2023–2024 Rivian R1S & R1T
Incorrect Weight on Tire Placard Label

NHTSA Recall No. 24V-458
Rivian Recall No. FSAM-1491

IMPORTANT SAFETY RECALL

Figure 2

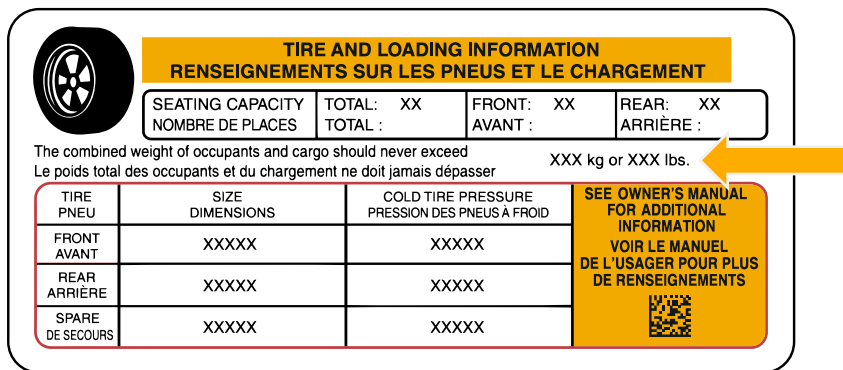
2. By comparing the existing and NEW labels, verify the vehicle equipped content is accurate. The only change will be the listed combined weight (See arrow in Figure 2).

5. Remove the paper backing from the NEW overlay label. Carefully align the label directly on top of the existing tire placard and apply. Press firmly across the entire label to ensure proper adhesion.
